# FMB110 Product Change Notifications

[Main Page](#) > [Advanced Trackers](#) > [FMB110](#) > **FMB110 Product Change Notifications**

**Product change notifications (PCN)** is the way of informing customers of upcoming changes related to Teltonika products. This includes outward appearance adjustments, hardware improvements, firmware changes, changes to package contents, etc. This page stores information regarding changes to the FMB110 tracking device. Below you will find a list of both upcoming and already implemented changes sorted from newest to oldest (top to bottom).

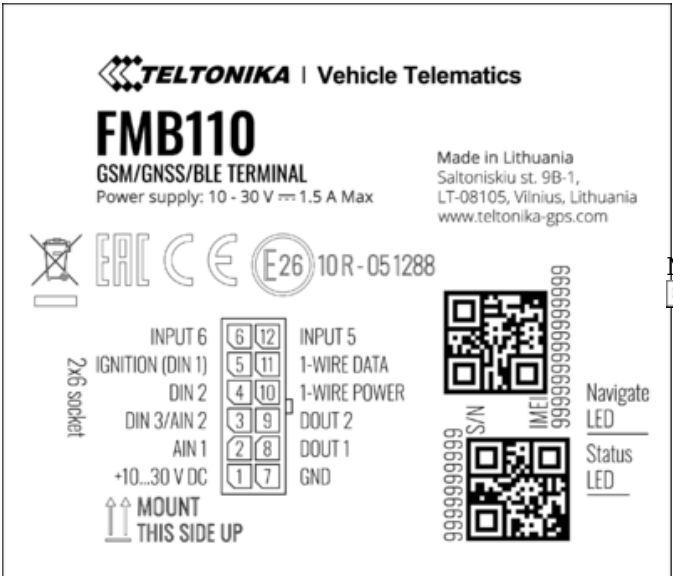
Change type	Firmware update	
Detailed description	Key improvements from last production firmware are listed in errata: <a href="https://wiki.teltonika-gps.com/view/FMB110_firmware_errata">https://wiki.teltonika-gps.com/view/FMB110_firmware_errata</a>	
Change reasons	Old version: FMB110 03.25.15.Rev.32	New version: FMB110 03.25.18.Rev.05
Product release date	FMB110 base firmware version update 2021 February 26th.	
<b>Affected products</b>		
Model	Affected order codes	Order code changes
FMB110	FMB110***** order codes with base Firmware	Update firmware
<b>Change impact</b>		
Risk assessment	Client's special firmware versions or order codes with special firmware will not be updated to latest base firmware automatically	
Suggested implementation plan	If you are using special firmware version and would like an upgrade to new features of latest base firmware, please contact your Teltonika sales manager.
